Date: July 24, 1998

To: T10 Committee (SCSI)

From: George Penokie (IBM)

Subject: Persistent Reservations

Figure 1 — Device server interpretation of PREEMPT service action

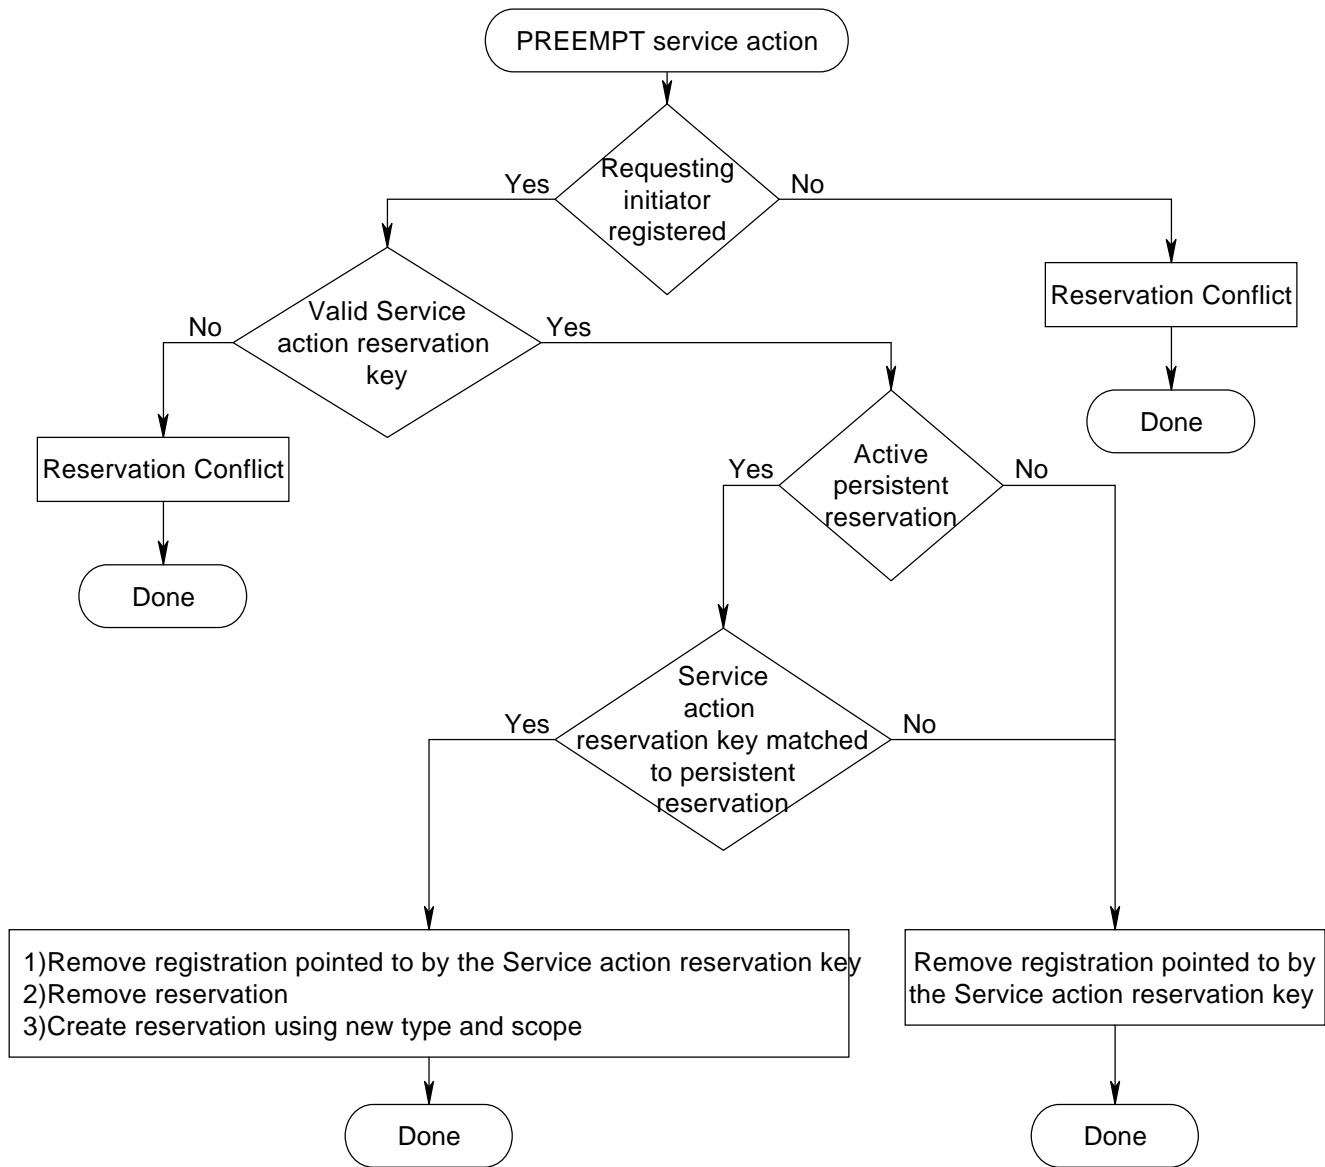
Editors Note 6 - GOP: The fact that you allow old commands to execute under the old reservation implies that the only sane way to do this is to treat the preempt as an ordered command. This means that if there is a stuck host, It may never get to this command. This is a deadlock condition. We can solve this by putting all of the commands under the new reservation. Is this desirable or even acceptable?

Editors Note 7 - GOP: The fact that you allow old commands to execute under the old reservation implies that the only sane way to do this is to treat the preempt as an ordered command. This means that if there is a stuck host, It may never get to this command. This is a deadlock condition. We can solve this by putting all of the commands under the new reservation. Is this desirable or even acceptable?
